MONTEREY PENINSULA WATER MANAGEMENT DISTRICT

DRAFT **AGENDA** **REGULAR MEETING OF THE CARMEL RIVER ADVISORY COMMITTEE**

EXHIBIT B

***Assessment of the Adequacy of the Environmental Impacts Analysis,
and Required Mitigations and Monitoring Programs, of the Final and
Supplemental Environmental Impact Report Prepared for the Santa
Lucia Preserve and the Potrero Subdivision***

Plate 1. Location of fault lines, wells, springs, and streams; Rancho San Carlos, Monterey County, CA. Many wells and springs are located along faults, as are significant lengths of the streams. Data are from CHS 1994.

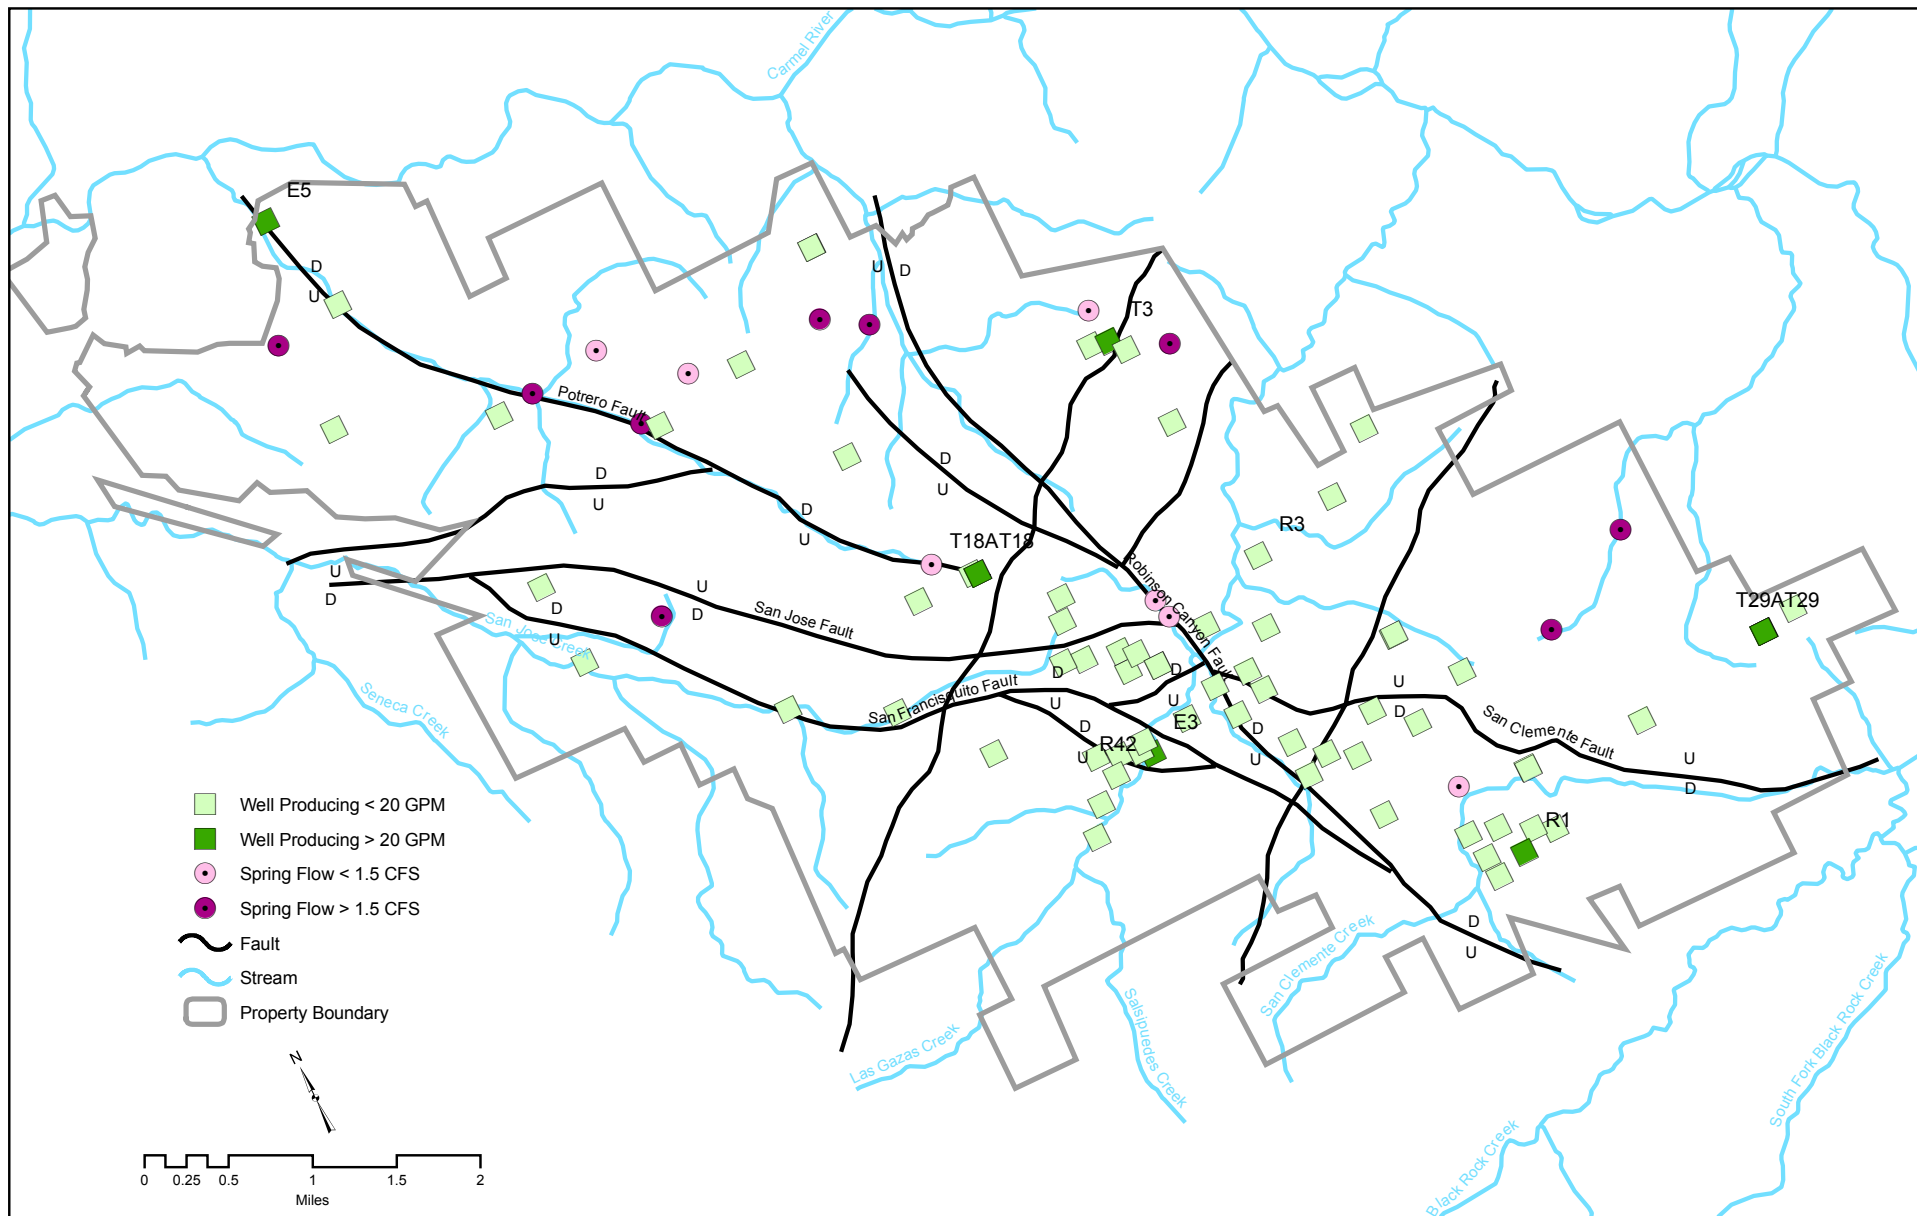
- NOAA Fisheries has prepared a GIS map (Plate 1) to examine the locations of the Preserve's wells and their spatial relation to faults and fracture zones. As Plate 1 shows, well fields are concentrated along the faults, the intersection of faults, and in the expected fracture zones in the headwaters of each creek system. The pattern of well placement is indicative of the anisotropy found in the Preserve's aquifer.

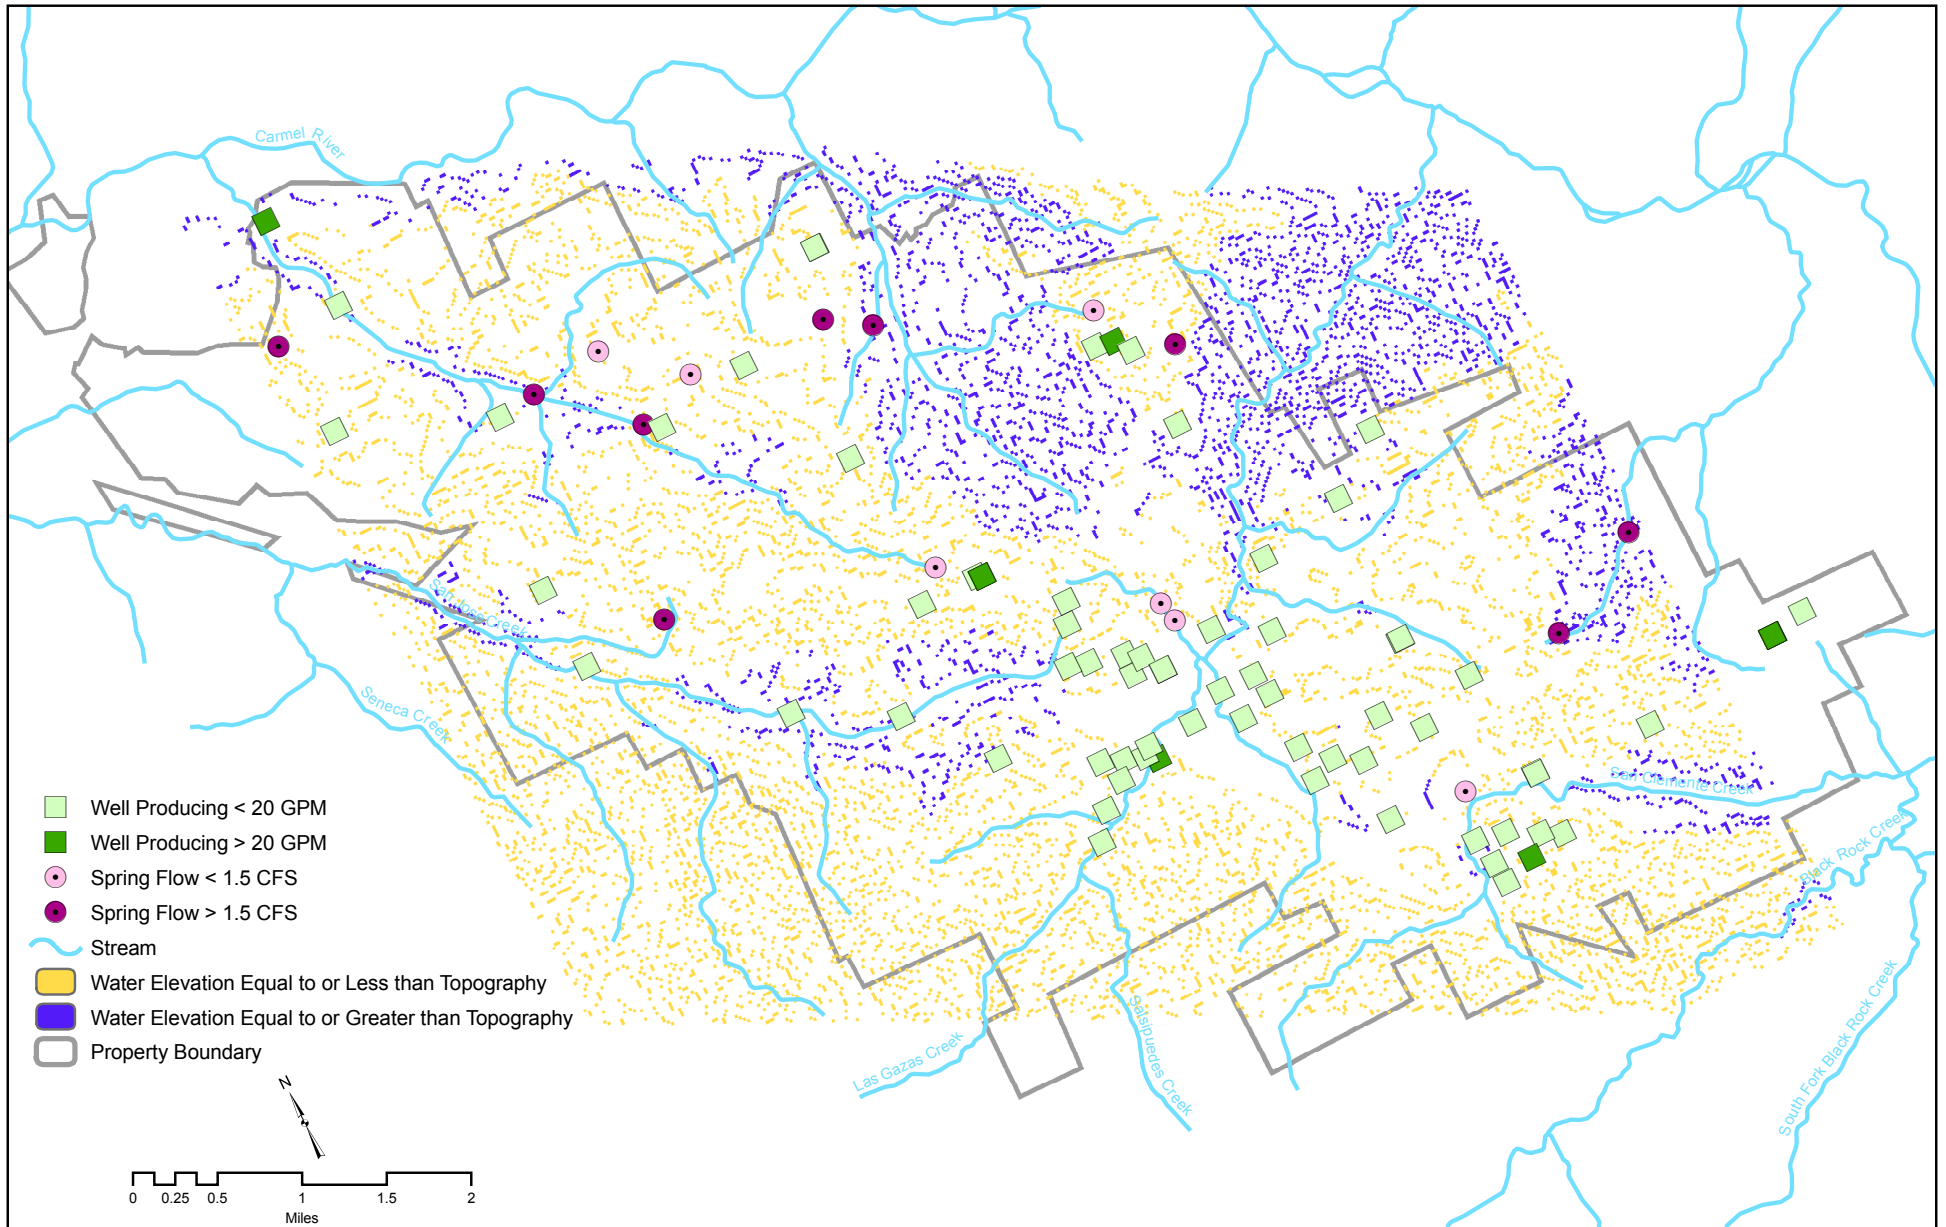
- “Seeps and springs occur in areas where groundwater intersects the ground surface.” (CHS pg 6-21). The environmental studies failed to develop this fundamental hydrologic data or assess its implications. We therefore prepared a GIS map that shows stream reaches where the aquifer water surface elevation exceeds the topographic elevation (Plate 2). Plate 2 provides a reasonable definition of ‘baseflow reaches’ for all streams emanating from the Preserve. The definition of ‘baseflow reaches’ in the FEIR and FSEIR must be revised to reflect the fact that wells drilled in any of these areas would have initially been artesian. Before these wells were drilled, the water table surrounding the creeks had a significant amount of head pressure; head dictates the rate of flow into the springs and seeps of the creek. Baseline streamflow conditions have not been systematically quantified, nor the natural variability quantified.

- Springs were also found in proximity to the contact zone between the aquifer and regional topography. Although the accuracy of our effort was limited by the available data, this method should have been used to accurately identify the hydraulic connections between springs, streams baseflows, and the aquifer.

Plate 4. Las Garzas Creek Watershed Area 13.2 Square Miles; widely spaced topographic lines representing rolling hills, broad valleys, and an alluvial aquifer

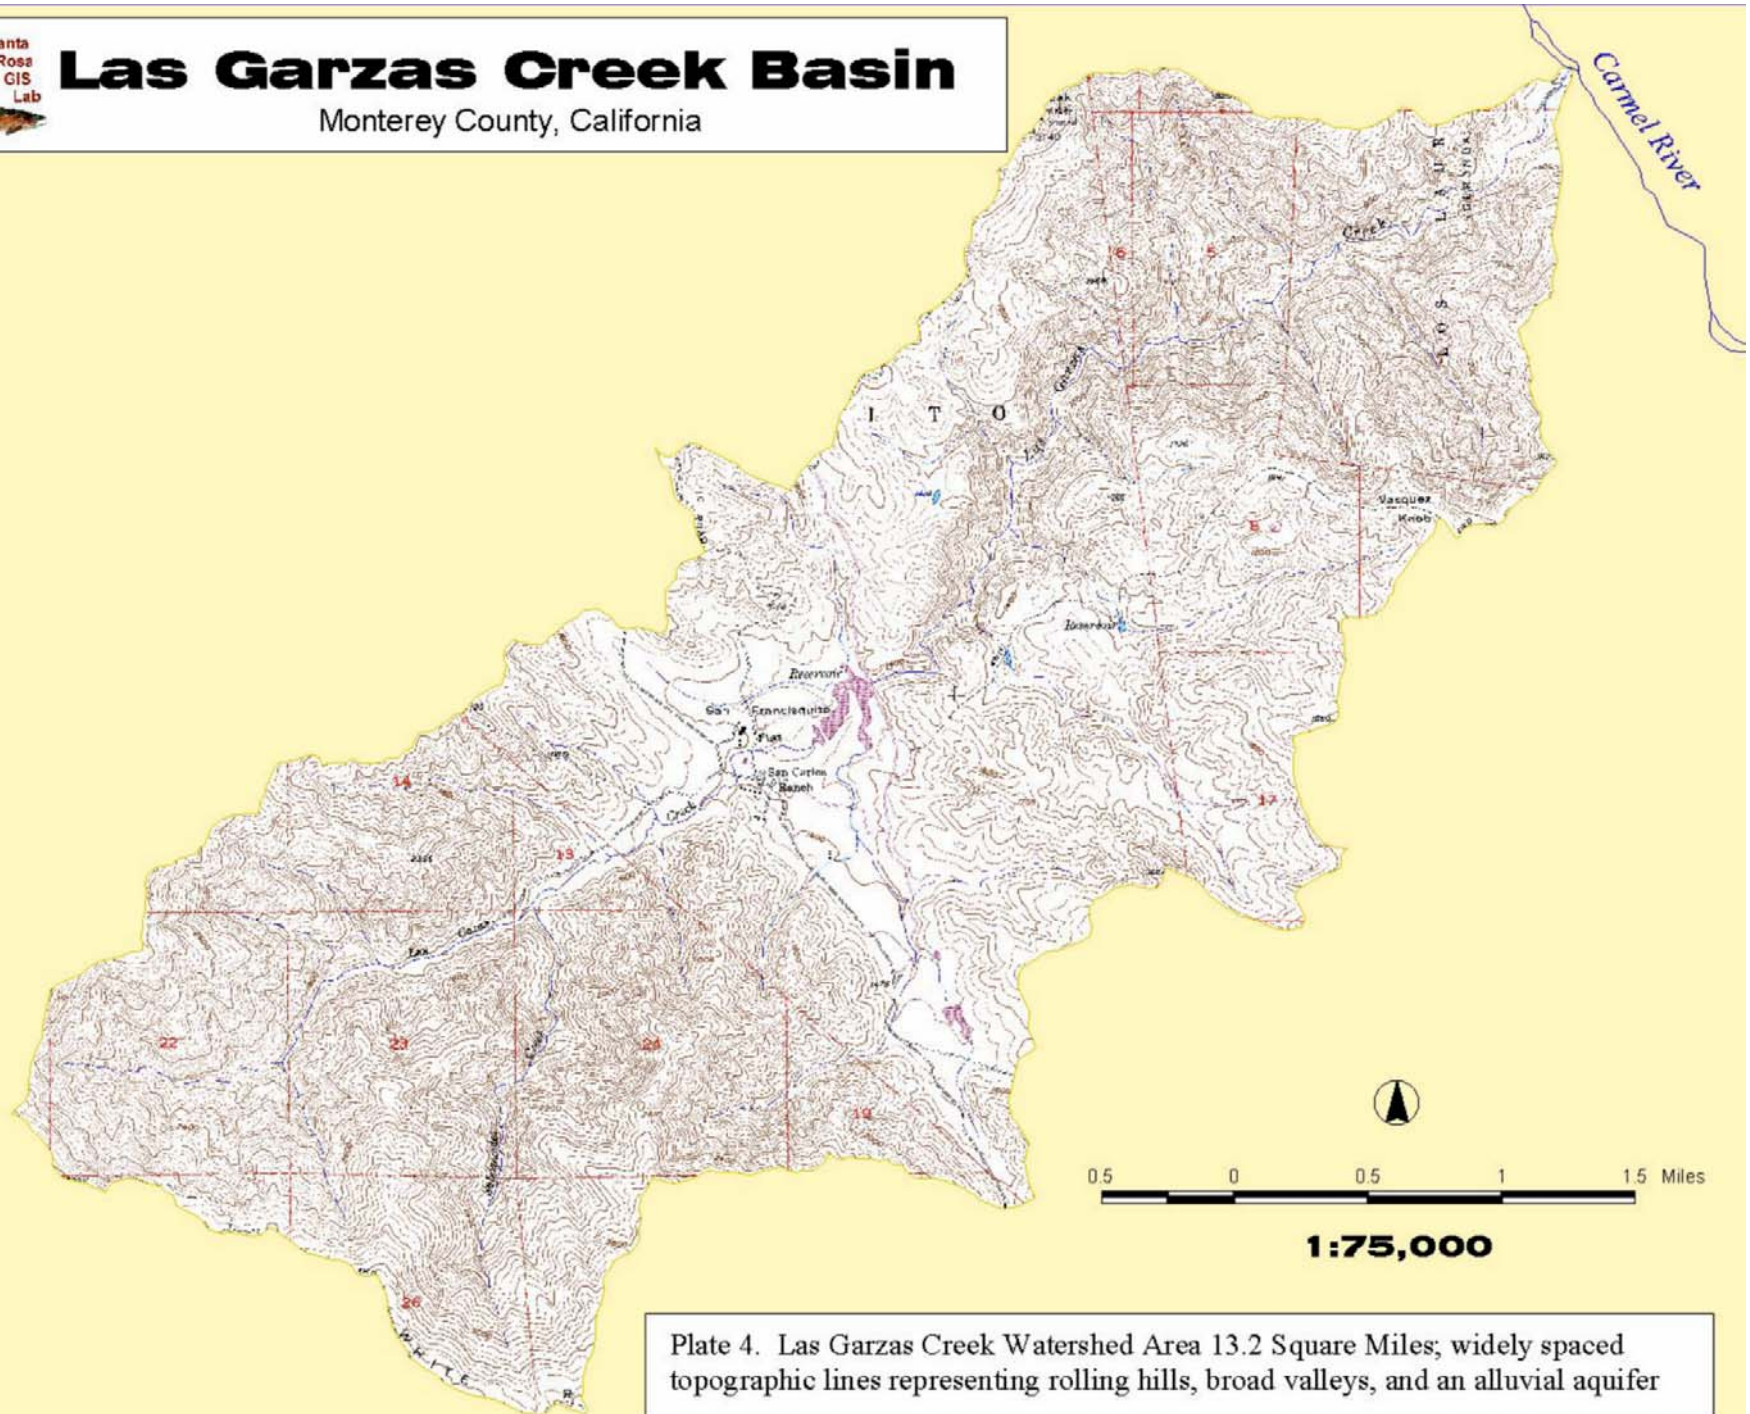
- Moreover, the extremely steep topography of virtually the entire Pine Creek watershed (*see* Plate 3), in addition to the higher intensity of rainfall, would indicate a higher percentage of precipitation results in surface runoff. By contrast, the broad valleys and rolling hills of the upper Las Garzas watershed (*see* Plate 4), which drain into the alluvial aquifer of the San Francisquito Flat, would indicate a higher percentage of precipitation in the Las Garzas watershed percolates into the ground, recharging the aquifer and, previous to development, would have supplied significantly greater summer baseflows in Las Garzas Creek as compared to Pine Creek.

Plate 5. Map showing the linear proximity between ground water wells and streams, Rancho San Carlos, Monterey County, CA. Wells shown are within 1000 feet of streams.

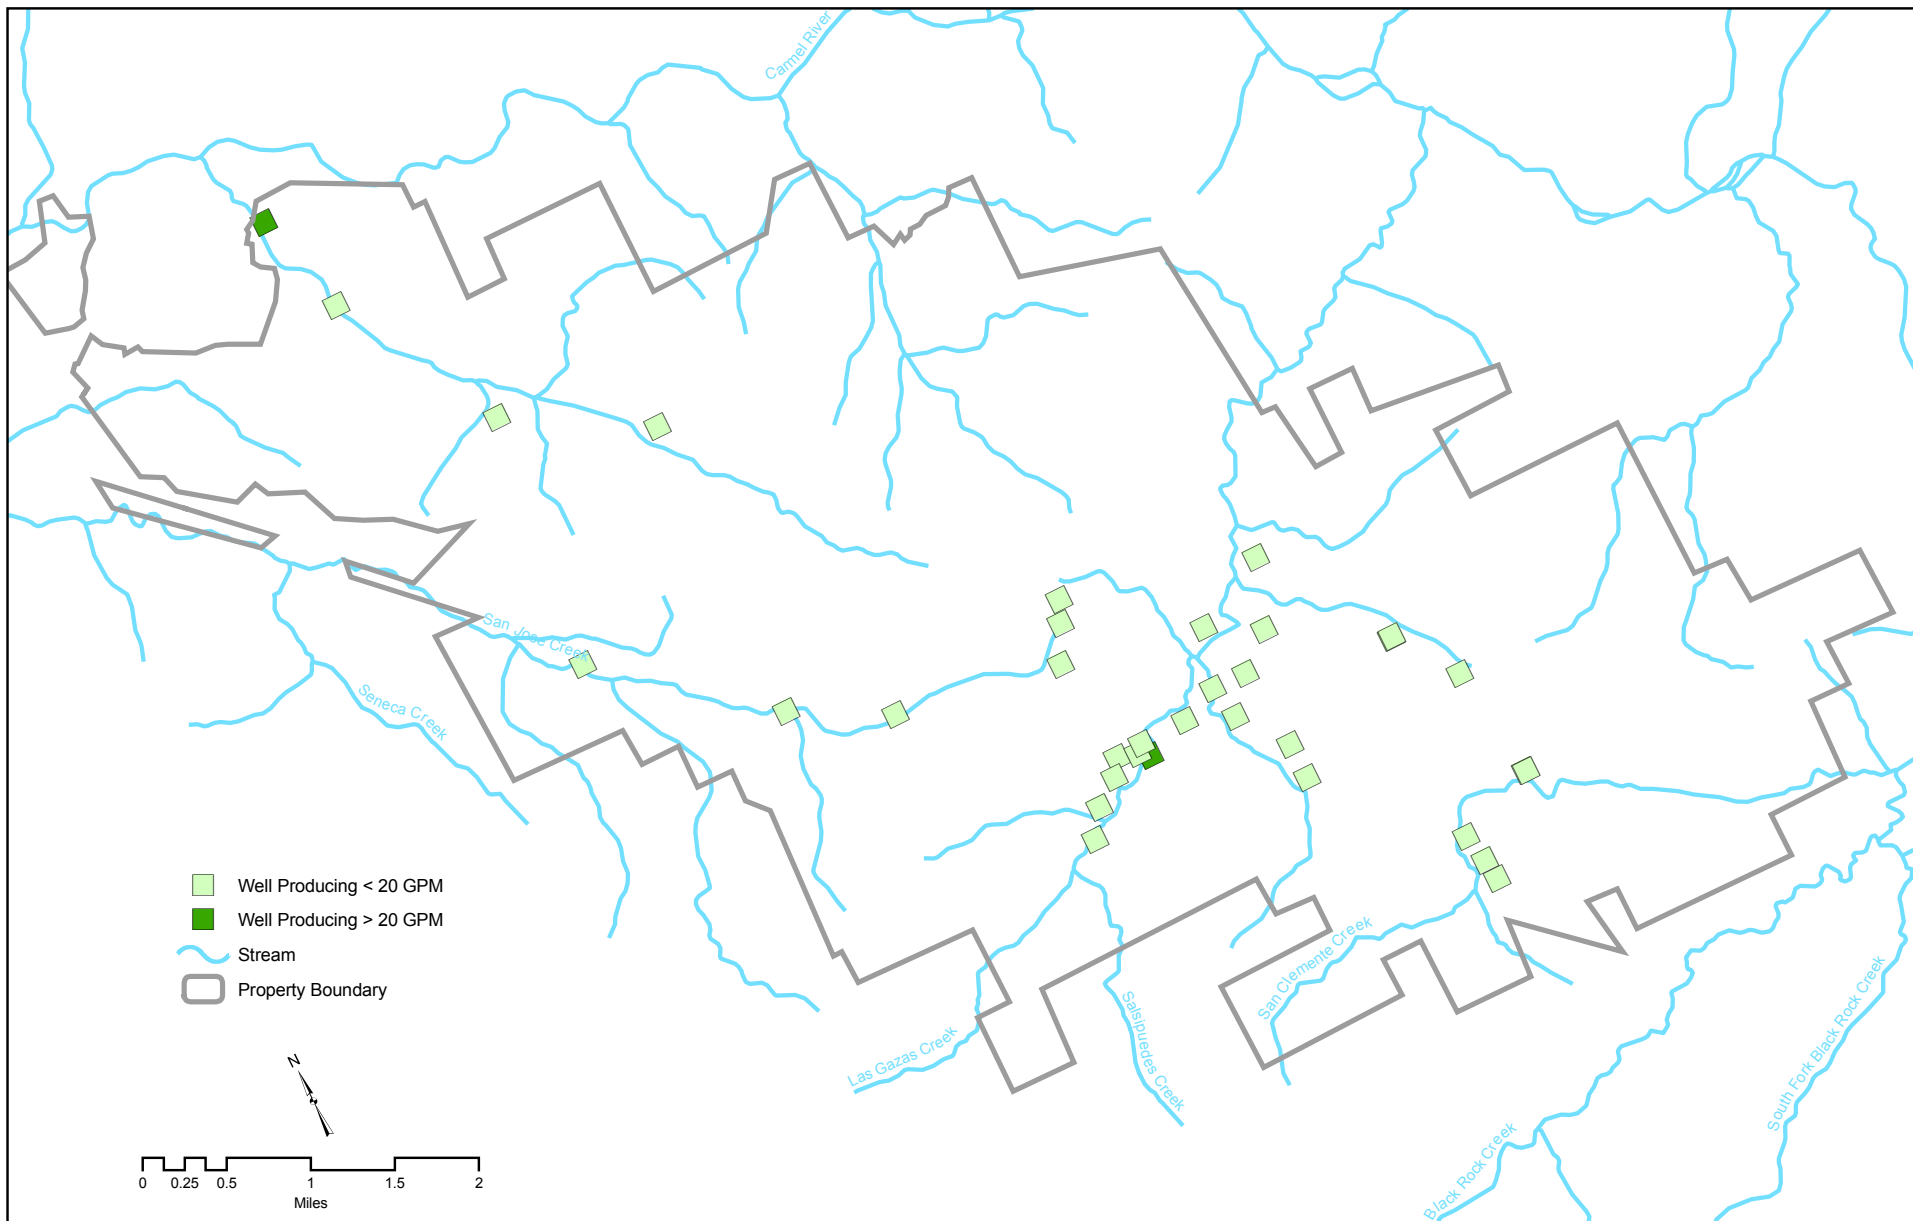
- Using GIS, NOAA Fisheries plotted all wells and streams to determine the distance between each well and the nearest stream (NOAA Fisheries Table 1). This analysis was then compared with Table 2 in Fugro (2003). Our GIS analysis found 34 wells were located within approximately 800 feet of streams, while Fugro listed only nine wells within 1000 feet of streams, labeling their analysis a “worst case scenario.” Thus Fugro, in their analysis of a “worst case scenario”, made the unsupported and likely mistaken assumption that only a small percentage of wells located near streams could potentially impact streamflow.
